Planning Ref: SD22A/0286

RE: CLARIFICATION OF ADDITIONAL INFORMATION Submission with respect to Planning Reference SD22A/0286 – Deane & Deane Ltd, - PERMISSION for the demolition of 2 no. sheds and the construction of 30 no. dwellings, at Main Street, Newcastle, Co. Dublin.

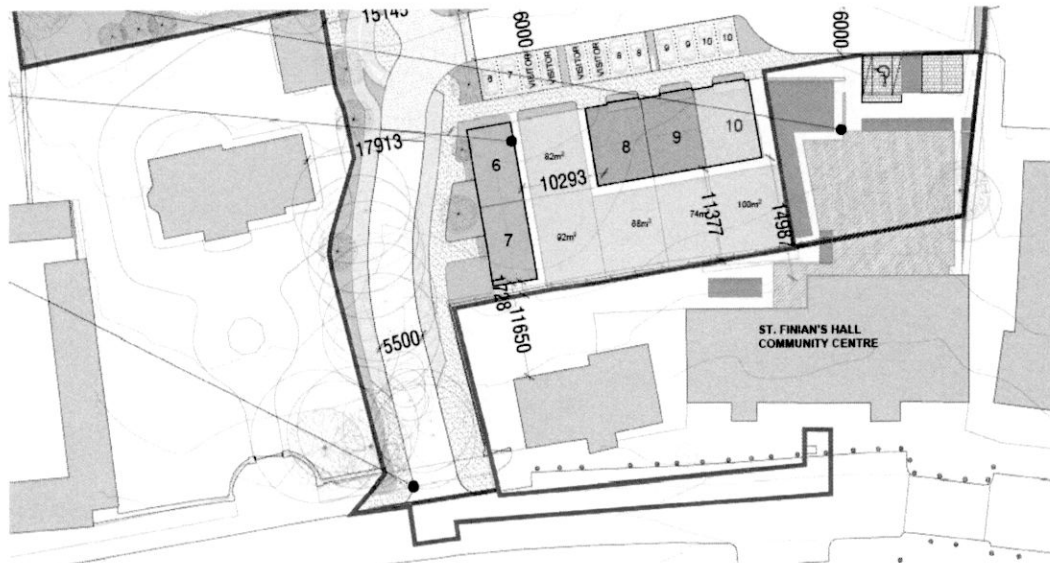
ITEM 2 (c) The applicant is required to update the site layout plan clearly indicating the proposed and existing site levels in this area with details on the proposed boundary treatment.

This information is not clear on the documentation provided and is critical to understanding the extent of the proposed development in this area and that the levels of the proposed development correspond with the existing levels of footpaths and carriageway in the Market Square site to facilitate future pedestrian and vehicular connectivity.

Clarification on site levels (existing and proposed) is also needed for SDCC Architects' Department to review potential connectivity with the Community Hall site from the north

RESPONSE: Refer to CS Consulting drawing NCA-CSC-ZZ-SI-DR-C-0016 that has been updated in order to provide clarity in relation to the relationship between the existing and proposed levels where the proposed development site abuts Market Square site and Community Hall site.
